FIELD NOTES

Service survey — Building A

Sample Project — 123 Example Ave

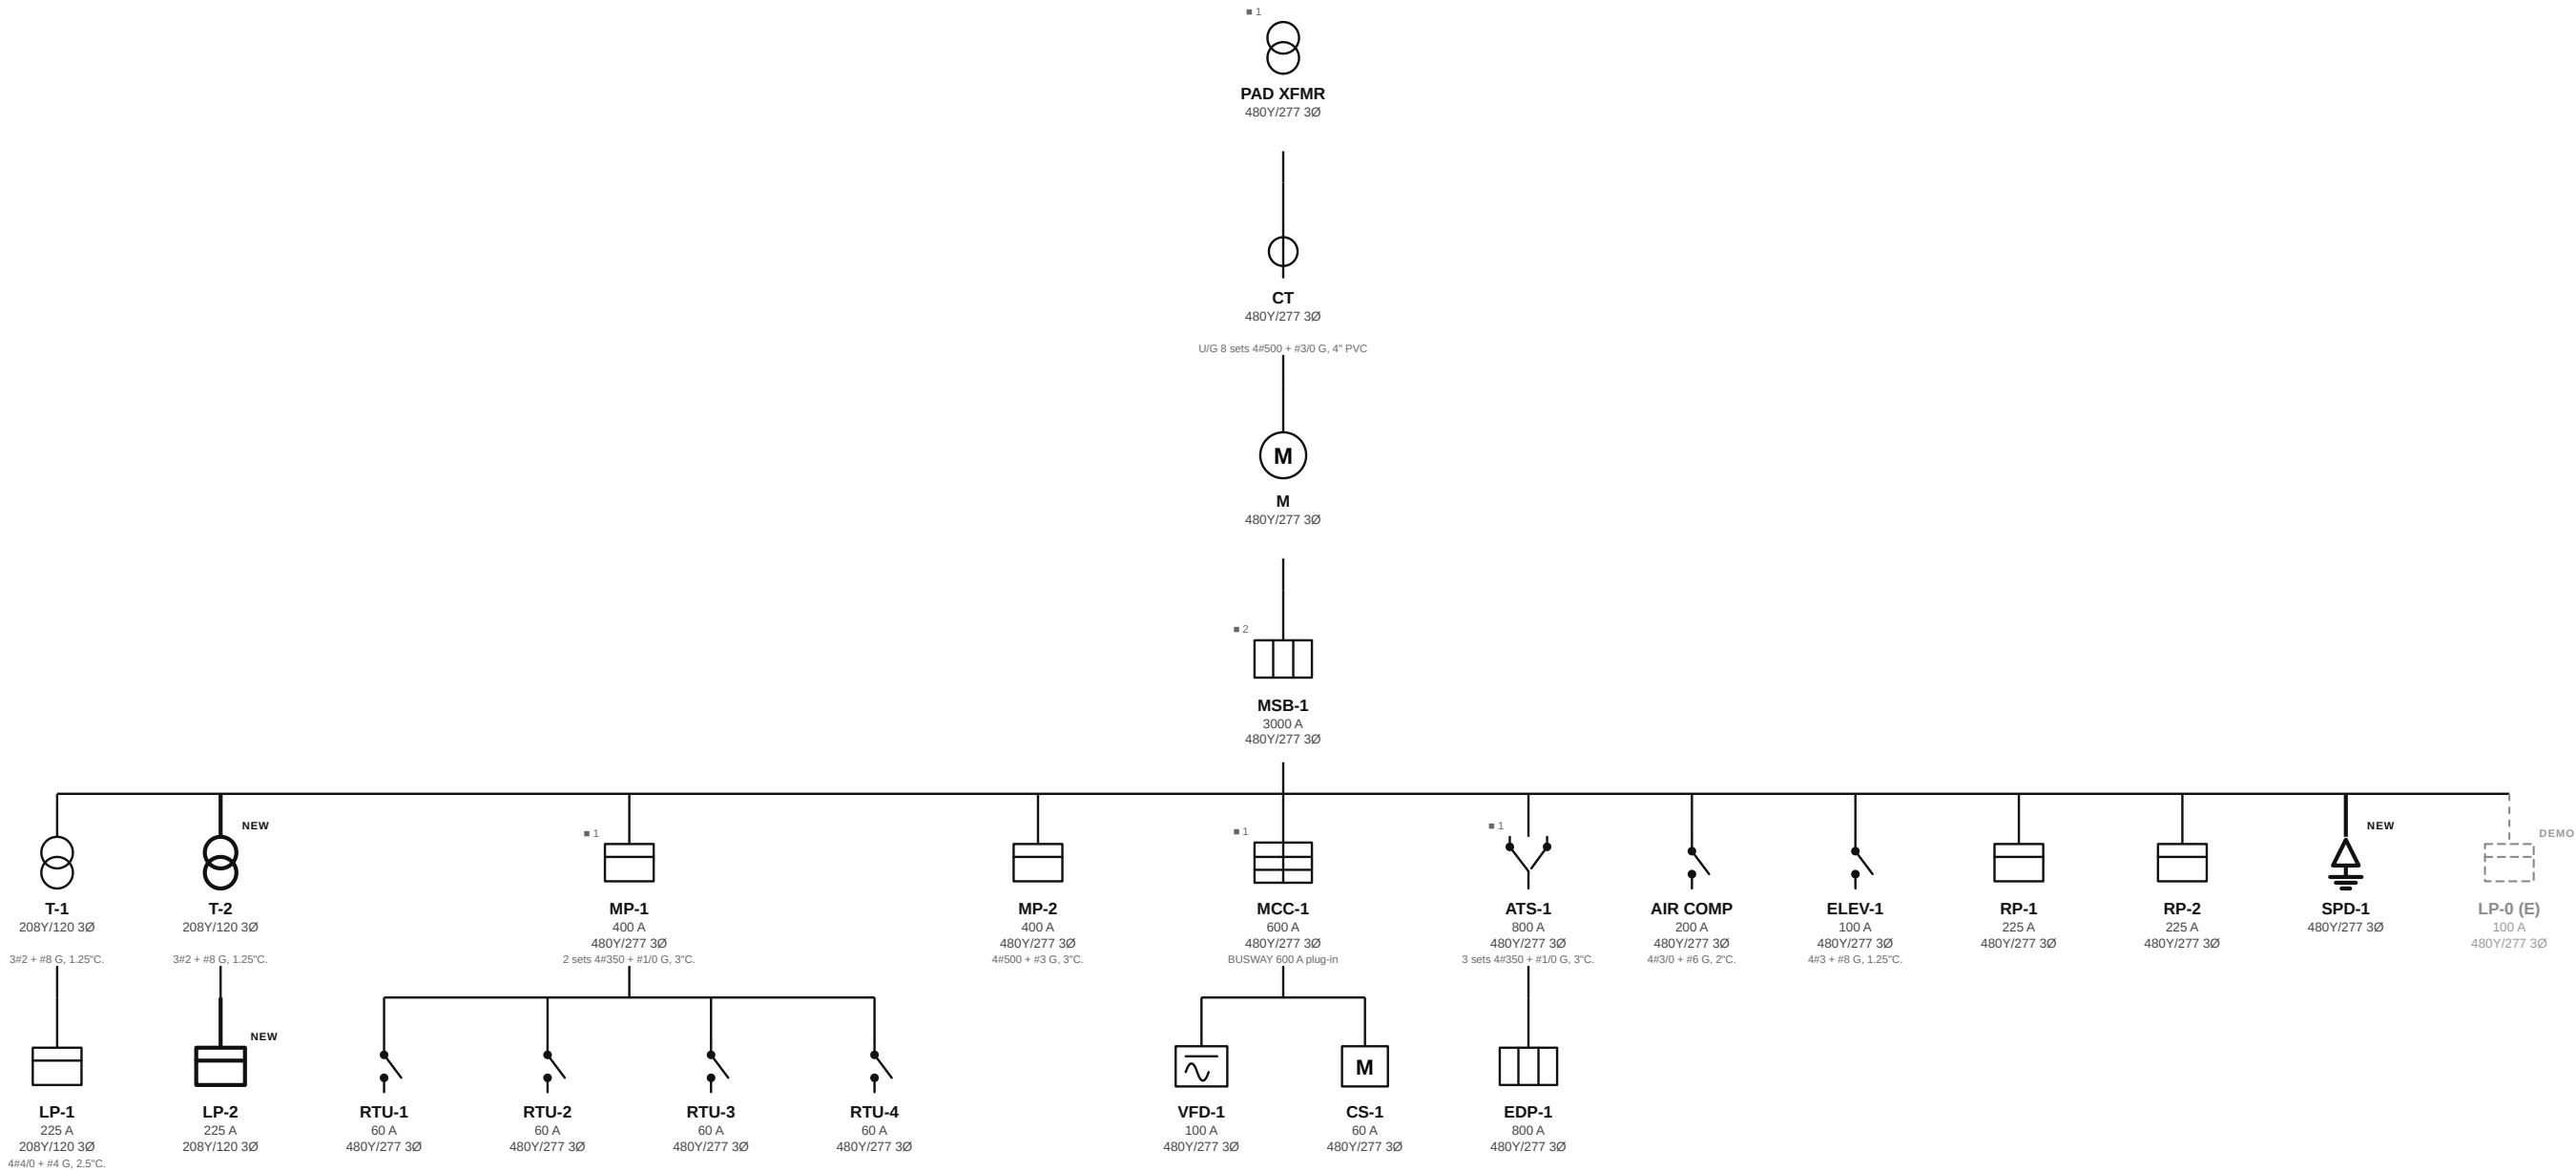
- REVIEW
- WARNING** T-1 and T-2 secondaries are 208Y/120; verify the panels they feed are rated for it.
- NOTE** MCC-1 is fed by 600 A busway plug-in — confirm the plug-in matches the bucket schedule.
- NOTE** SPD-1 is new at MSB-1; confirm it lands on a dedicated breaker, not a lug tap.
